Design Report Addendum
Response to RFIs

Mixed-Use Development with Infill Affordable Housing
13–17 Oxford Street and 2 Verona Street, Paddington NSW 2021

Date	Purpose
SSD Reference:	SSD-87245208
DPHI Reference:	RFI-120198738 (3 May 2026) and Addendum (7 May 2026)
CoS Reference:	R/2025/23/A (5 May 2026)
Prepared by:	Tonkin Zulaikha Greer (TZG) Architects
On behalf of:	WT Malouf, care of 17 Oxford St Pty Ltd

Units 1.01 and 1.02 combined into a single, dual aspect, 3 bedroom apartment

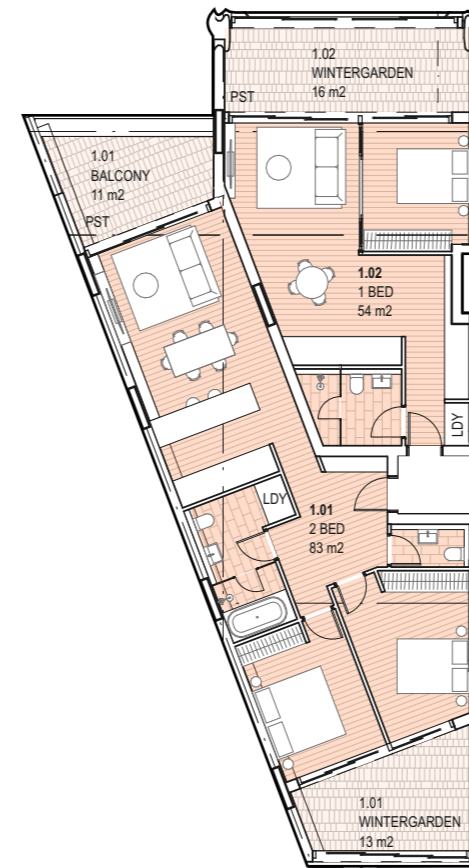
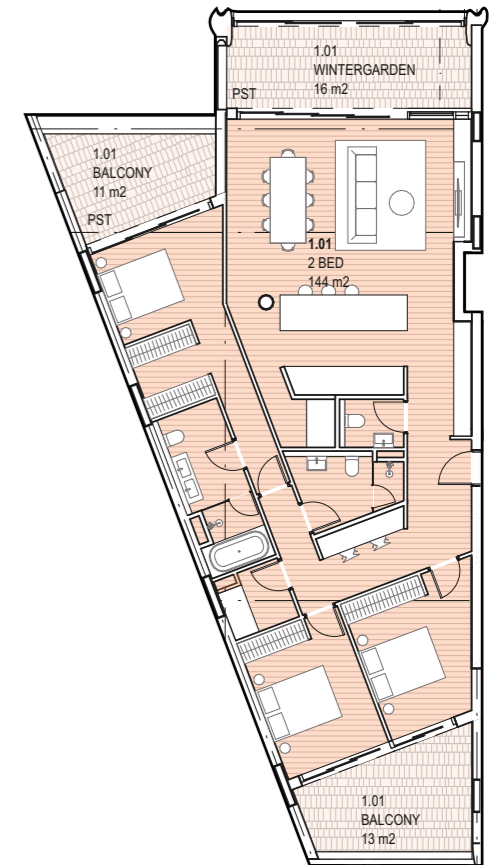
CoS Item 2 - Natural Cross Ventilation	
Agency	City of Sydney
RFI No.	2
RFI Comment	
<p>a) The City raises continued concern that the proposed development does not achieve adequate natural cross ventilation in accordance with Objective 4B-3 of the ADG.</p> <p>b) The supplied plans and elevations of terraces A, B, C and D do not clearly demonstrate the operable windows relied upon to provide cross ventilation. The supplied cross ventilation diagrams do not demonstrate that compliance is achieved.</p> <p>c) In addition, 17 apartments within the development still exceed the maximum cross-through depth of 18m from glass line to glass line. It is recommended that the depth of the building fronting Oxford Street is reduced to achieve the maximum 18m depth. This would also improve the poor amenity outcome of bedrooms facing walls in the western corner for apartments 1.13, 2.11, 3.11, 4.11, 5.09, and 6.06.</p> <p>d) There is also further scope to increase the number of dual-aspect apartments fronting Oxford Street.</p>

d) The number of dual-aspect apartments fronting Oxford Street has been increased by amalgamating unit 1.01 and 1.02.

Terrace C Plan showing relocated boundary wall to unit 2.10

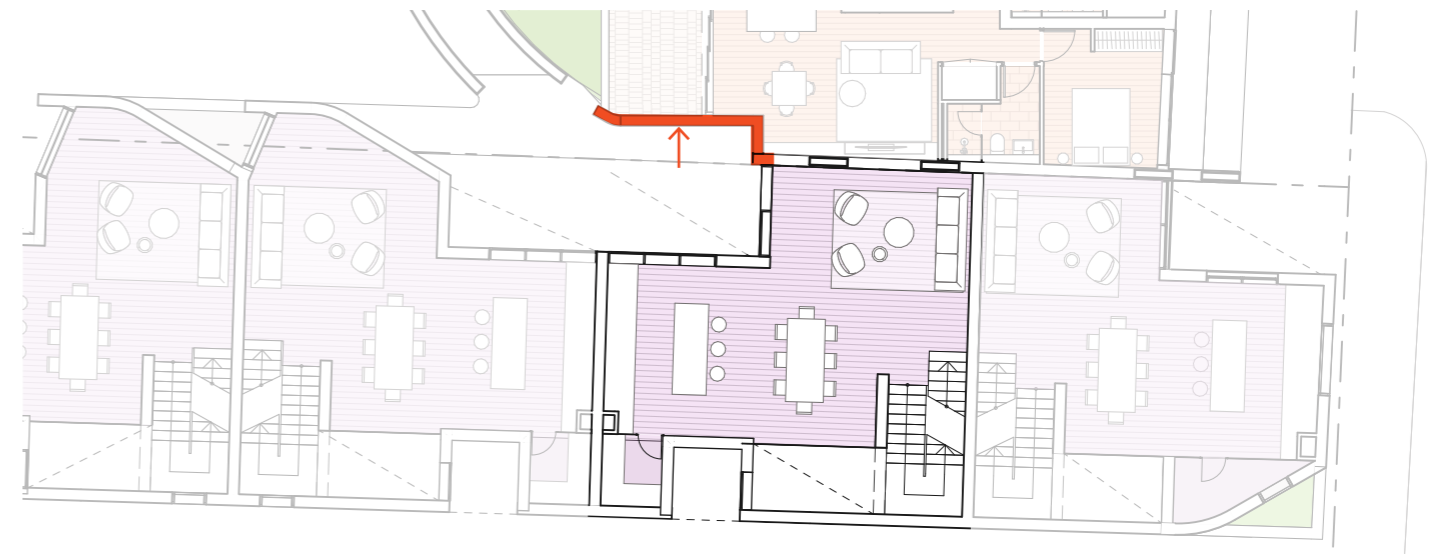
CoS Item 3 - Verona Terraces	
Agency	City of Sydney
RFI No.	3
RFI Comment	
<p>Limited changes to the configuration of the proposed terraces have been made. Continued concern is raised regarding the following:</p> <ul style="list-style-type: none"> a) The 1.7m (at its minimum) setback from the south-western boundary should be increased to 3m so as not to fetter future development on 4 Verona Street and provide adequate privacy in accordance with Objectives 2F and 3F-1 of the ADG. b) Limited outlook is provided from Terrace C, which looks directly to the raised access corridor and the blank wall of the proposed apartments to the north-east. c) Proposed ground level landscape areas to Terraces A–D will receive very little sun and will likely fail. d) There are continued privacy impacts from Verona Street to the floor-to-ceiling windows and glass louvres in Terrace D. 	
Design Response	
<ul style="list-style-type: none"> a) The proposed setback to the western boundary represents a significant improvement on the existing condition and achieves an acceptable outcome in the context of this constrained inner-city site. <p>The ADG building separation objectives are directed at achieving visual and acoustic privacy, access to natural light, and outlook for residents of both the subject development and adjoining properties. In this instance, the proposed setback delivers a materially better outcome against each of these measures than the existing condition. The adjoining Rose Terrace properties have limited or no existing separation from the current Oxford Street buildings, and the proposed development improves this relationship.</p> <ul style="list-style-type: none"> b) Further design amendments have been made to improve outlook from Terrace C. The balcony and party wall of apartments 1.11, 2.10, 3.10 and 4.10 have been set back away from Terrace C, increasing the separation between Terrace C and the adjacent apartments across all levels. This amendment widens the view opening to the courtyard from within Terrace C and its private 27sqm rooftop outdoor area, improving both the sense of enclosure and the quality of outlook available to residents of Terrace C. The distance between the terrace C outdoor area and the party wall of unit 3.10 is approximately 3.5m c) Landscape areas: <p>Landscape architects Wyer and Co have reviewed the landscape design in accordance with city of Sydney’s concern around the landscape areas for terraces A to D receiving little sun. A planting palette has been carefully selected comprised of shade-tolerant, native species considered suitable for the anticipated site conditions.</p>

- d) Visibility into terrace D from Verona street has been reviewed and design amendments made to increase privacy. Terrace D has a walled landscaped courtyard of 20m². 15m² of this area has no basement or footing area below it and is therefore deep soil, meaning that a substantial tree can be grown in this area. Planting within this courtyard includes a Gymea Lily and cabbage tree palm, which will also provide privacy from the street. The landscape wall itself is between 1900 and 2300mm high (variance due to the slope of the street). The landscape wall exceeds eye level when viewed from the same side of the street as the terrace, so privacy measures focus on mitigating visibility from the opposite footpath. An opaque perforated screen has been added at balustrade height to each window, allowing the windows to remain fully operable with a generous open area for ventilation while preventing direct sightlines into the terrace from the street. A new ground floor window has also been added to the Terrace D Verona Street facade to improve cross-ventilation, positioned at a high level to minimise any privacy impact.

2 21 JUN 09AM PROPOSED

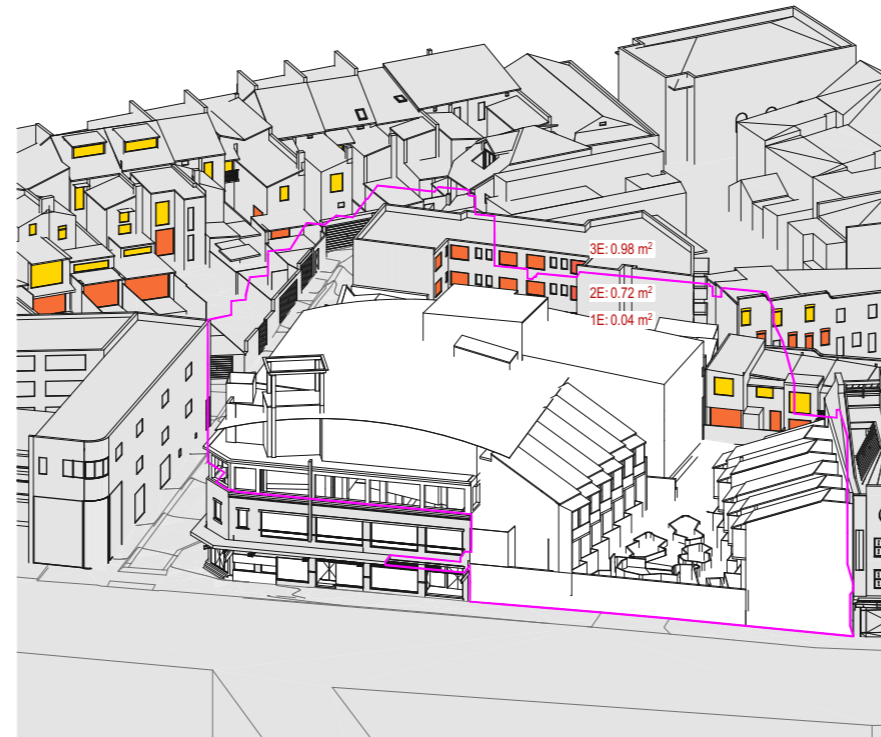
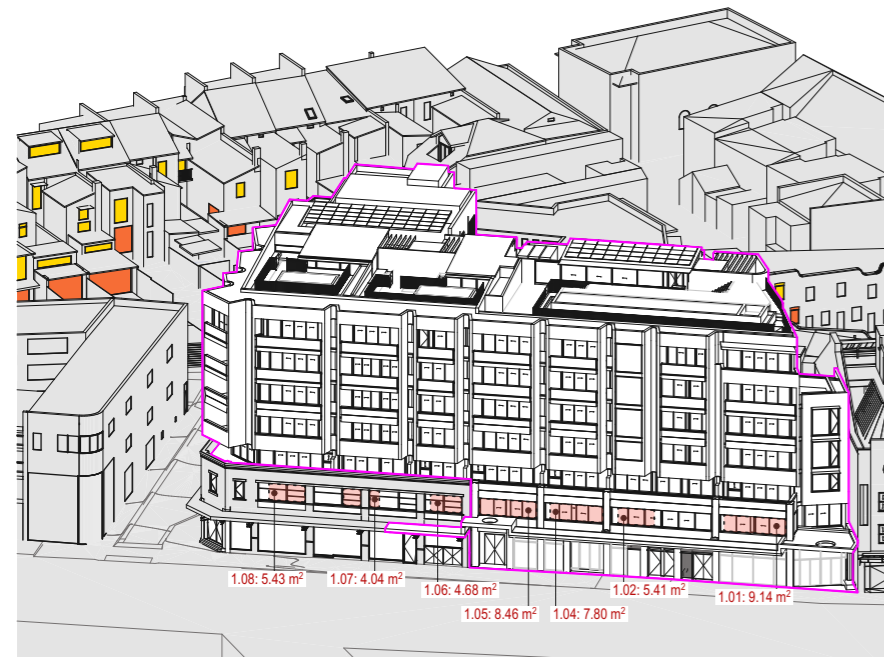
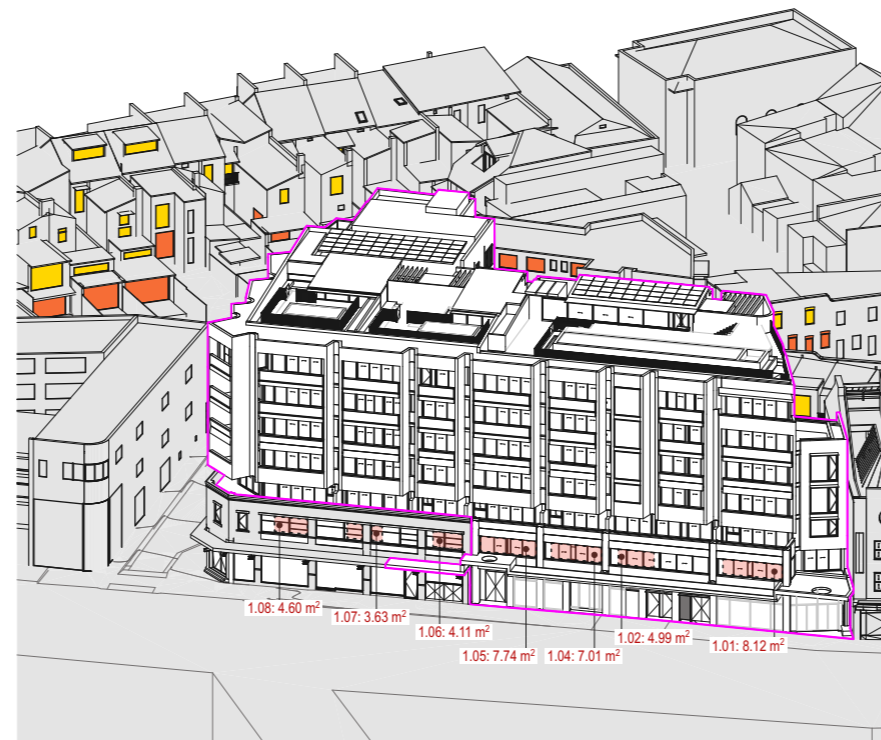
CoS Item 4.1 - Overshadowing	
Agency	City of Sydney
RFI No.	4.1
RFI Comment	
<p>The submitted views from the sun demonstrate that impacts to apartment 2E at 4 Verona Street have not been improved by the amended proposal. Amendments to the proposed rooftop could improve the impacts to this apartment and a design modification condition to this effect is recommended within Annexure B.</p> <p>Annexure B text excerpt:</p> <p>The design of the building must be modified as follows:</p> <p>(a) Amend the rooftop pergola structures to ensure no further overshadowing to apartment 2E at 4 Verona Street from the development between 9am – 9.30am on June 21.</p>	
Design Response	
<p>Apartment 2E at 4 Verona Street did not receive 15 minutes of solar access to its primary private open space prior to the proposed development. The shadow analysis prepared for the previous submission confirms that apartment 2E currently receives only 1.02m² of sunlight at 9:00am, diminishing to less than 0.72m² by 9:15am.</p> <p>The proposed development reduces the marginal impact at 9:00am, with no material change to solar access from 9:15am onwards.</p> <p>As apartment 2E does not currently receive 15 minutes of direct sunlight to its primary private open space at mid-winter, this objective is not engaged. The proposed development does not worsen the existing non-compliant solar access condition in any material respect, and the proposed rooftop design is considered acceptable in this context.</p> <p>Updated ADG solar access compliance tables and revised drawings are included with this submission.</p>

NOTE: Under existing conditions during the Winter solstice, 4 Verona St Apartments 2E and 3E receive the minimum 1m² at 9:00am, but less than 1m² at 9:15am. Apartment 1E receives less than 1m² at both times.

Proposed Ground Floor Plan Showing Survey Levels

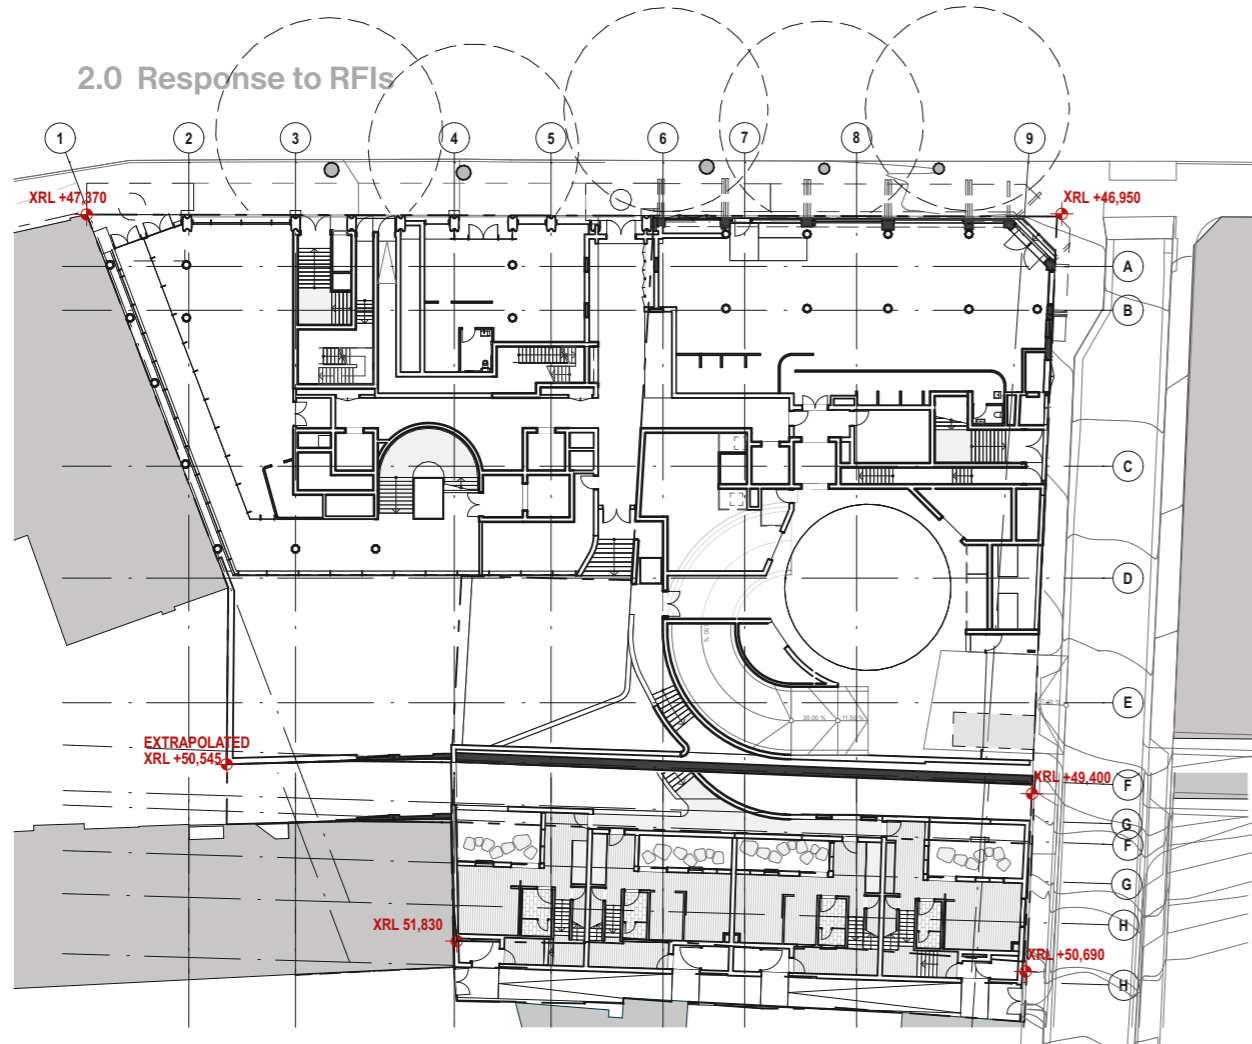
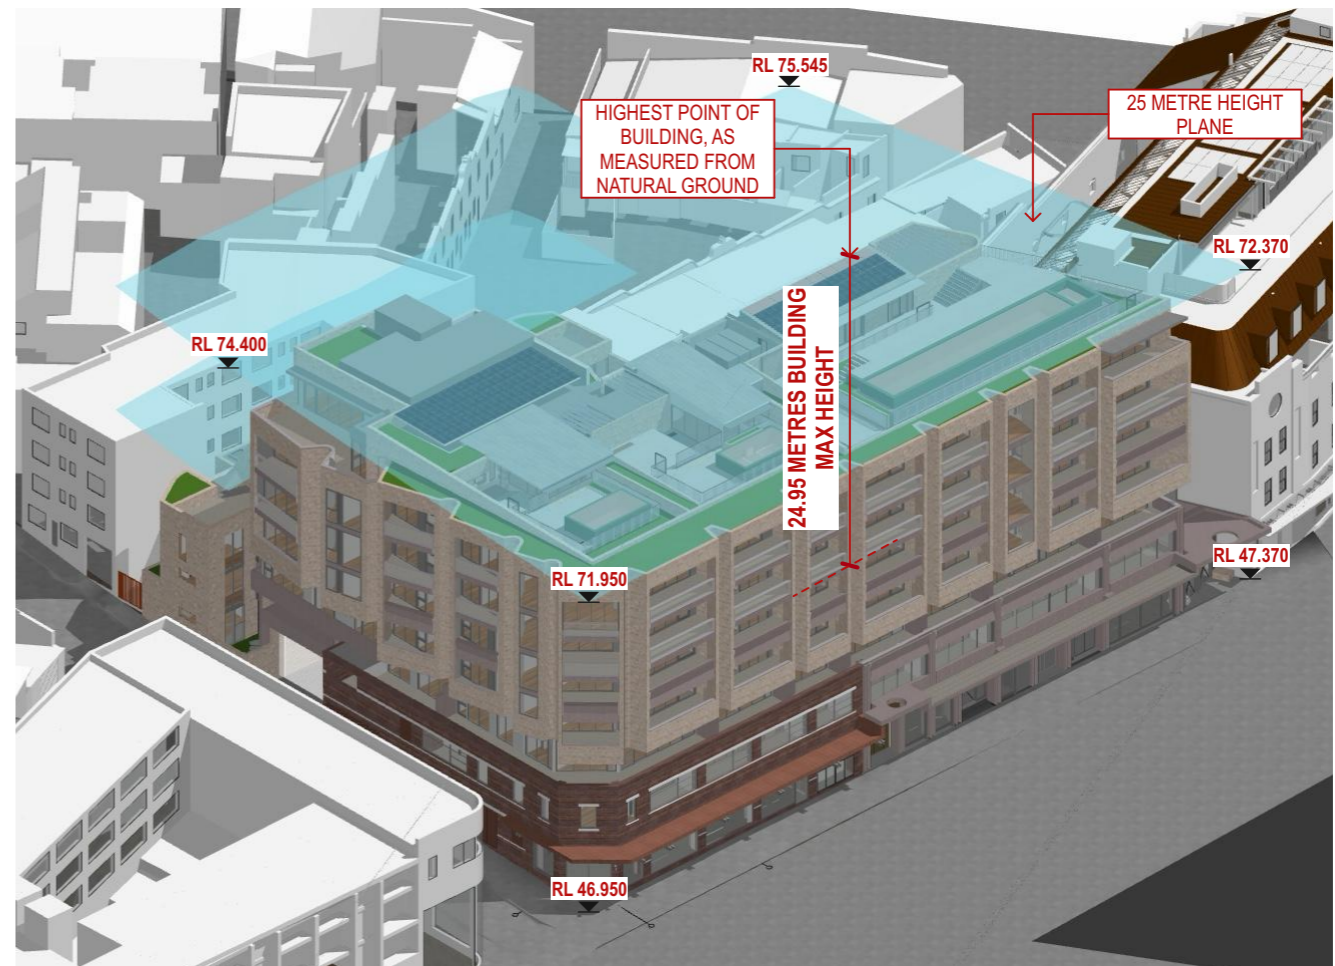
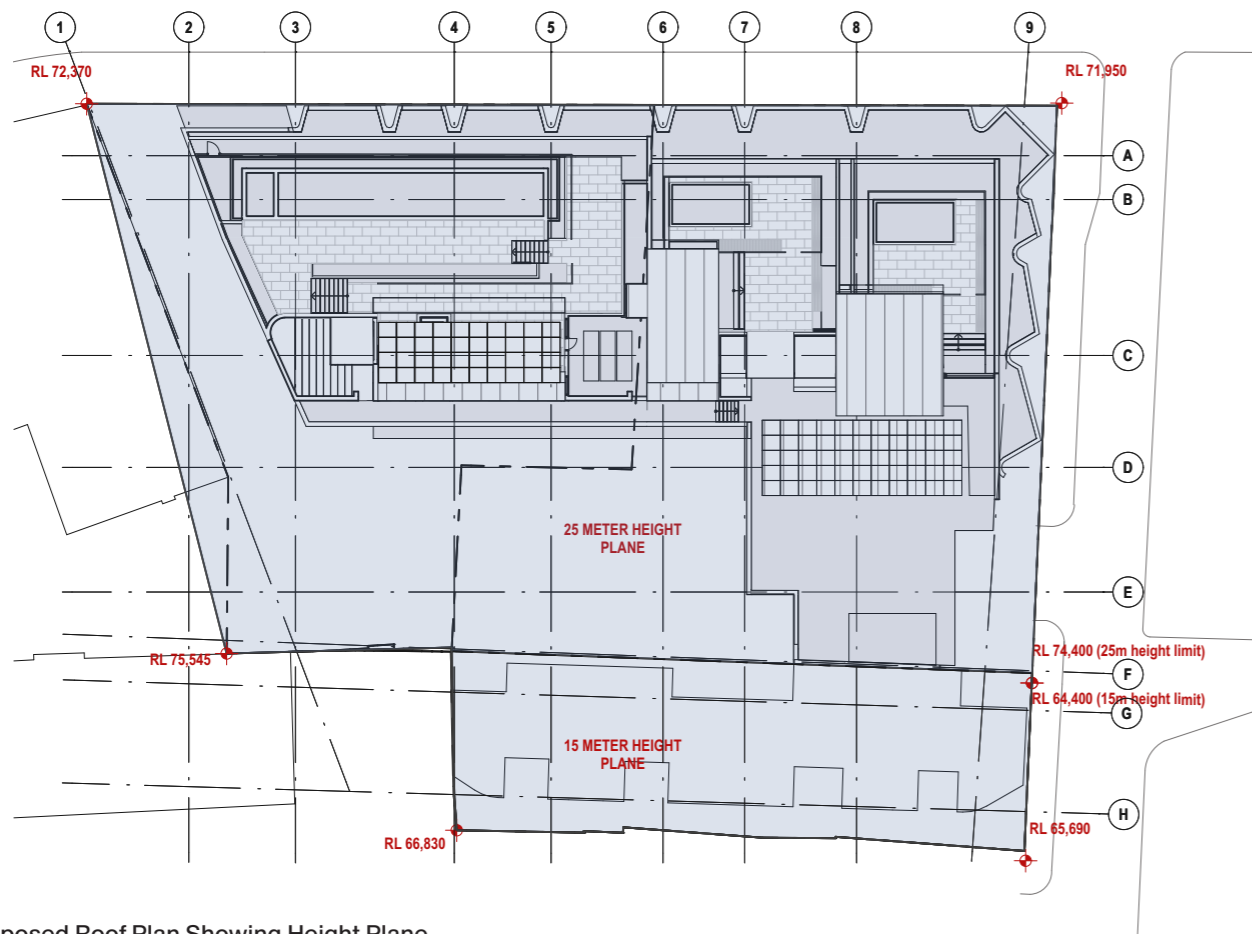
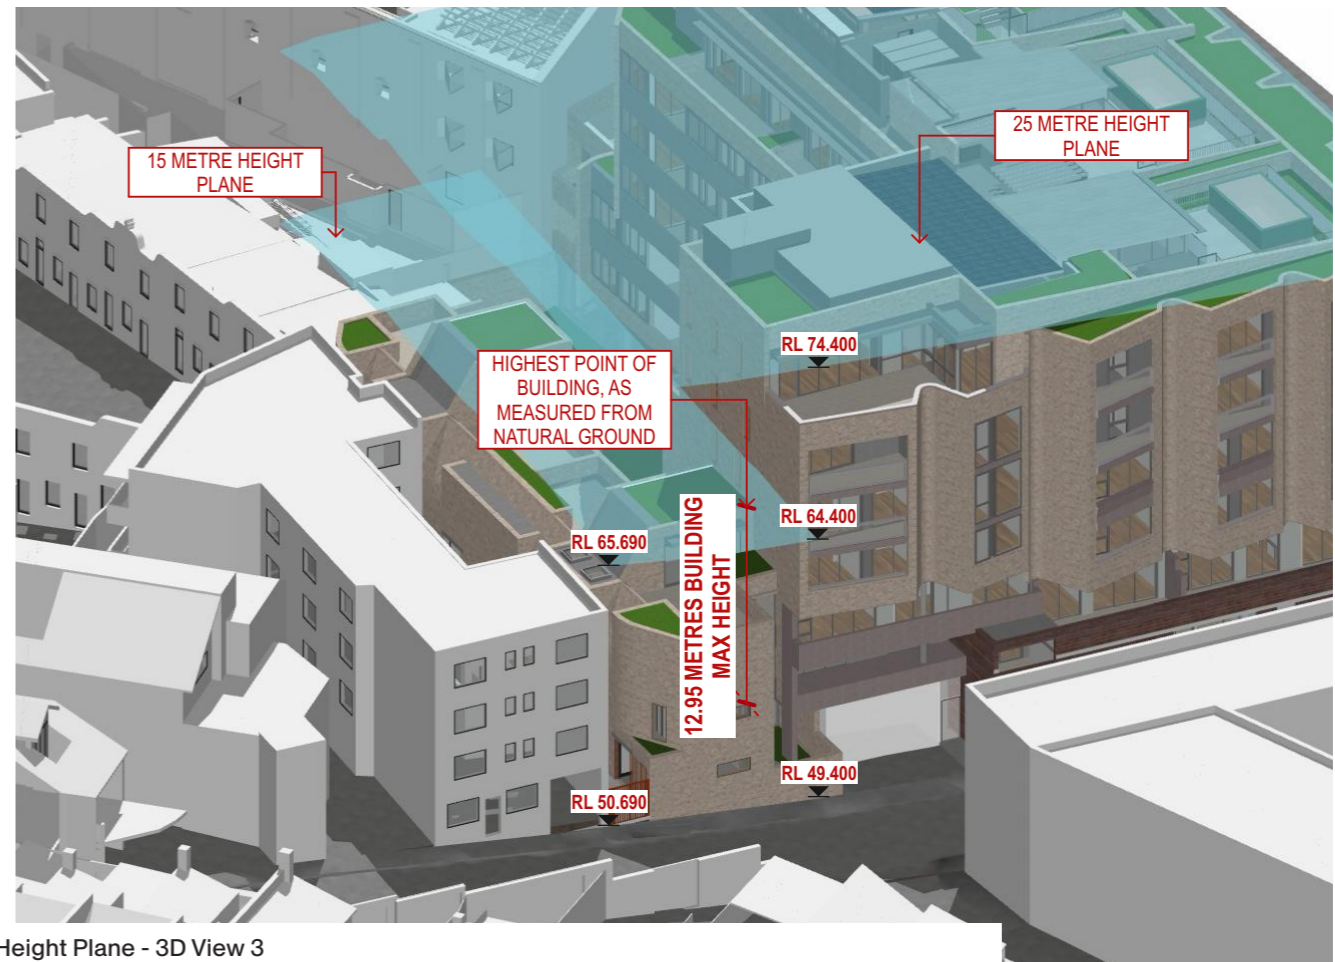
CoS Item 6.3 - Building Height	
Agency	City of Sydney
RFI No.	6.3
RFI Comment	
<p>Survey levels have not been provided on the amended plans in support of the proposed natural ground level measurement. While the Bettar methodology may be the suitable method for calculating the existing ground level, the levels from which the height has been extrapolated are required to be provided. The Department must be satisfied that the ground level and therefore height level is accurate.</p>	
Design Response	
<p>A new diagram is provided to illustrate the existing ground levels from which the natural ground level is determined. The natural ground level has been determined using the Bettar method, a standard surveying technique used to establish pre-development ground levels where the original topography has been disturbed by previous construction. The method interpolates the natural ground surface from survey points taken at the site boundaries and surrounding undisturbed ground, providing a reliable baseline for measuring building height and basement protrusion above natural ground.</p> <p>Survey points have been taken from the survey prepared by Boxall Surveyors (issued 16 December 2025). Existing relative levels are shown on the amended ground floor plan, denoted with an "XRL" prefix.</p>
